AMENDMENT NO. ONE TO PROFESSIONAL SERVICES AGREEMENT WITH PSOMAS FOR ENGINEERING DESIGN SERVICES FOR THE WATER MAIN TRANSMISSION MAIN VALVE REPLACEMENT - PHASE 2 & ALTA VISTA REGULATOR RELOCATION PROJECT

ENGINEERING DESIGN SERVICES FOR THE WATER TRANSMISSION MAIN VALVE REPLACEMENT - PHASE 2 & ALTA VISTA REGULATOR RELOCATION PROJECT – AMENDMENT NO. 1

Amendment No. 1 additional services to include additional design/drawings for the following changes to the project:

OUTLET VALVE VAULT DETAIL NO.1

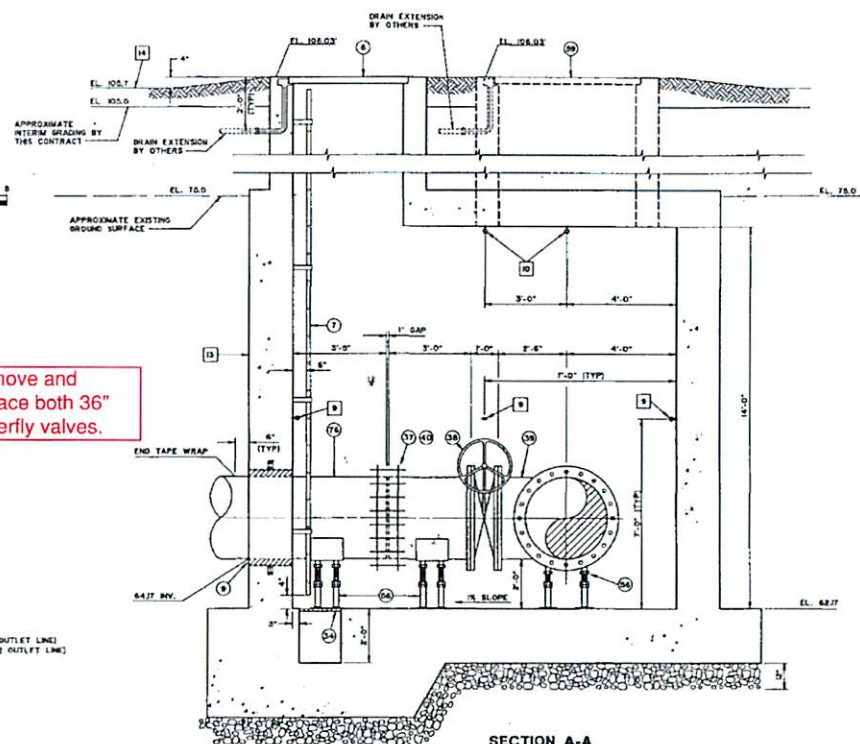
16th Street Reservoir and Pump Station (Attachment A)

Replace two 36-inch butterfly valves (BFV's) located within a concrete vault at the 16th Street pump station. This item excludes any improvements to the vault and vault appurtenances. The vault is to be protected in place.

**WATER TRANSMISSION MAIN (PHASE II)
 VALVE REPLACEMENT**
 VALVE MCB_121 AND MCB_122 E. COAST HWY AT JAMBOREE RD
 CITY OF NEWPORT BEACH
 PUBLIC WORKS DEPARTMENT
 W-XXXX-S
 SHEET 10 OF 19

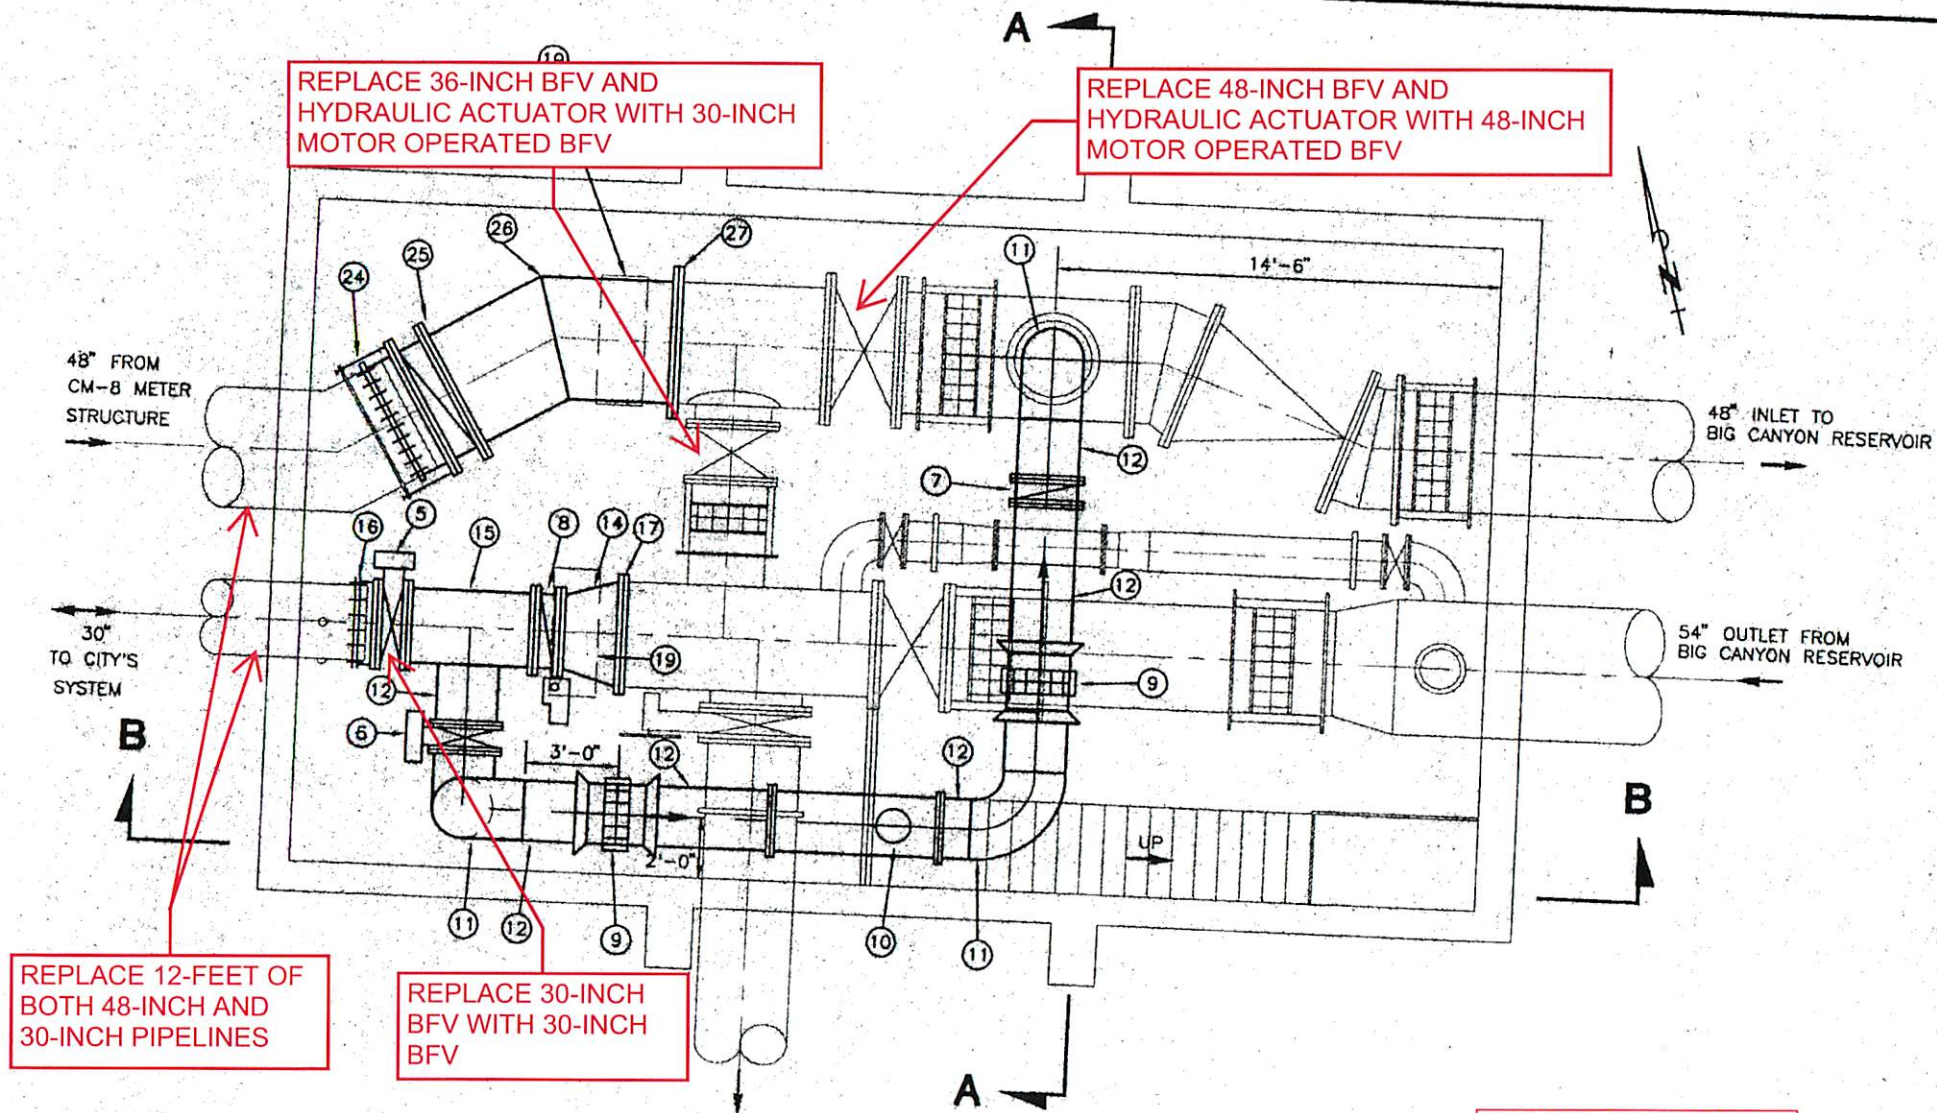
Jamboree Road and Back Bay Drive (Attachment B)

This work is based on the City's 90% review comments on Sheet 10. The work includes abandonment of a 10-inch DIP water main in Jamboree Road from PCH to Back Bay Drive and connection of the existing 12-inch ACP and 10-inch DIP water mains to the existing 30-inch RCSCP water main at the intersection of Jamboree Road and Back Bay Drive.
